Groundwater Sustainability Commission
for the San Luis Obispo Valley Groundwater Basin

NOTICE OF MEETING

- a) Receive an update on the installation of monitoring well (SLV-23).
7. **Public Draft of the Groundwater Sustainability Plan Review and Comments** (WSC Consultant Team: Michael Cruikshank and Dave O'Rourke) **3:55- 4:40 (45 mins)**
Recommendation

Response to Comments CH 9 and 10 and GDE TM

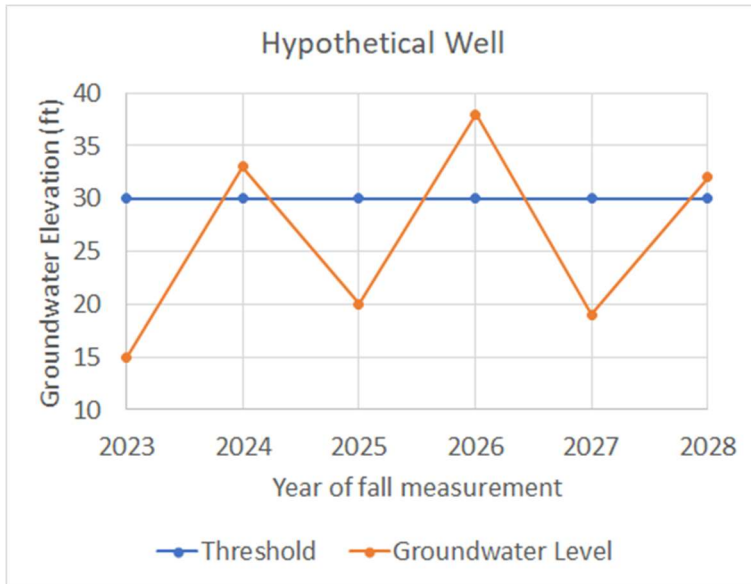
13 This section does not adequately address how groundwater level measurements at the RMSs will be
14 indicative of undesirable results to depletions of interconnected surface water. In other words, there is no
15 language that qualifies well level measurements at the selected RMSs as useful indicators for harm that
16 could be done to GDEs that rely on interconnected surface water or groundwater.
